#### 187th session

## Proposal for the 01 series of amendment to UN Regulation No. 136 (Electric vehicle L)

### Submitted by the Working Party on Passive Safety \*

"Figure 1

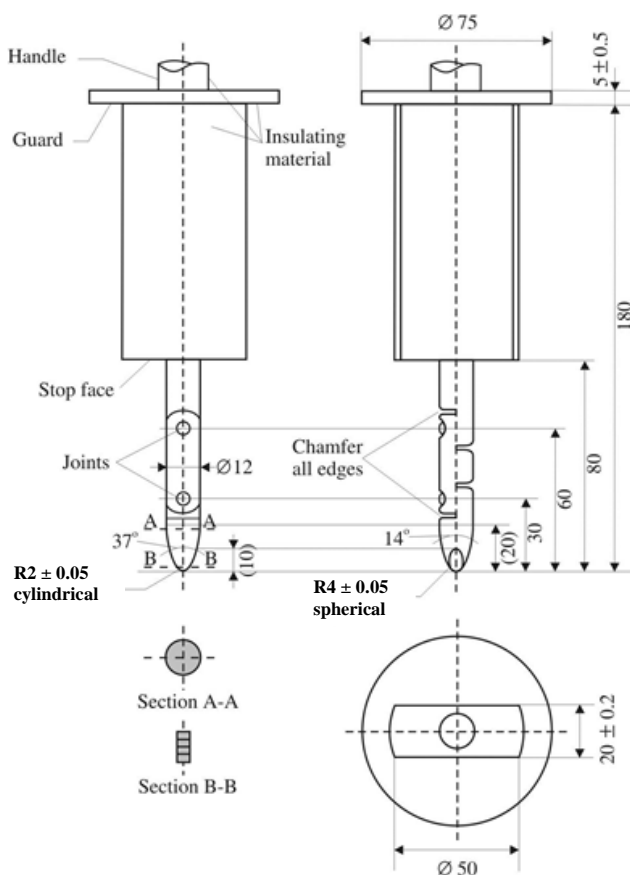
Annex 3, Figure 1, shall be deleted.

Annex 3, insert new Figure 1 to read:

**Jointed Test Finger**

Material: metal, except where otherwise specified

Linear dimensions in millimeters

Both joints shall permit movement in the same plane and the same direction through an angle of 90° with a 0 to +10° tolerance."
